# Peer Review of Infrastructural Services Assessment Related to an Application for a Change to the Selwyn District Plan

Broadfield Estates Limited Edward Street Lincoln

Selwyn District Council

25 September 2009

Figure 1 Lincoln Water Supply Layout

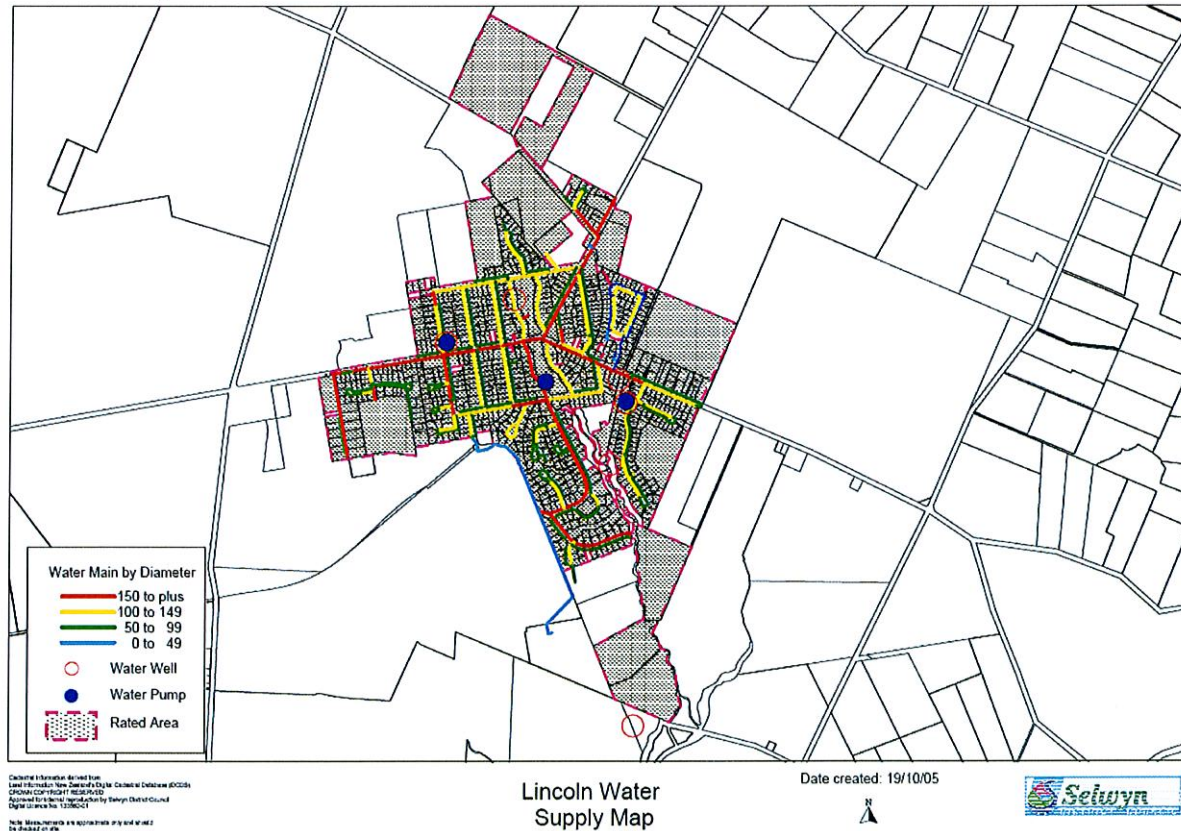
Upgrading and funding of the water supply network to provide for development, including that proposed in this plan change application, is expected to be relatively straightforward provided the necessary resource consents can be obtained for any new wells. Information is considered adequate at this plan change stage.

We recommend that further information be provided ahead of any subdivision consent application to allow for the expected substantial lead time for consenting of any additional well or wells. That information should include:

- Confirming the capacity of Council's current and proposed network to provide for peak summer and fire flow demands related to the proposal
- Defining any requirements brought about by the proposal for an additional well or wells, including where any such wells would be situated, and how and when they would be provided and consented, together with information on expected capital, operating and monitoring costs.

Updating of Council's water supply network model at the applicant's expense is expected to be required.

**Figure 3 Proposed Wastewater Network Layout for Structure Plan**

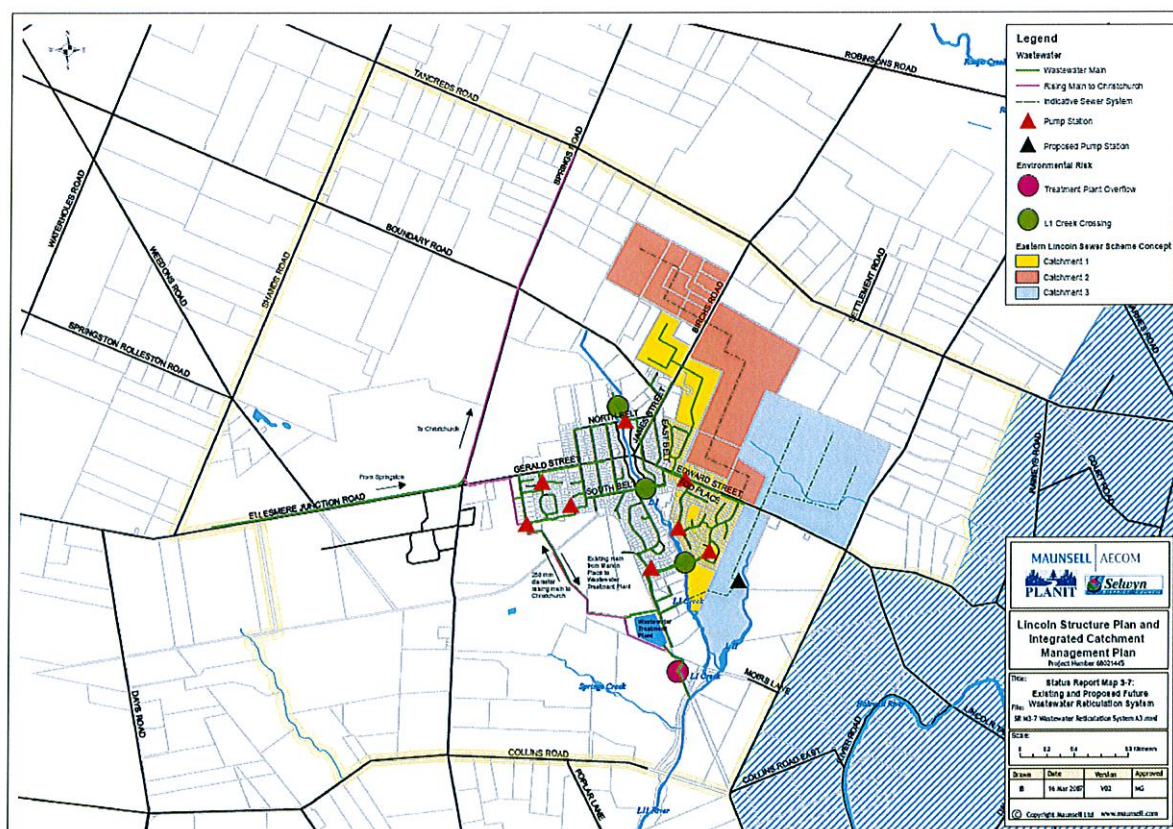
The local wastewater network as proposed in the application is similar to that proposed through the Structure Plan process. It includes gravity pipelines, a central pump station and pressure discharge offsite to Council's network. It is expected to be relatively straightforward and functional to design and build. Information is considered adequate at this plan change stage. Design details including connections with adjacent blocks can be defined closer to subdivision consent stage.
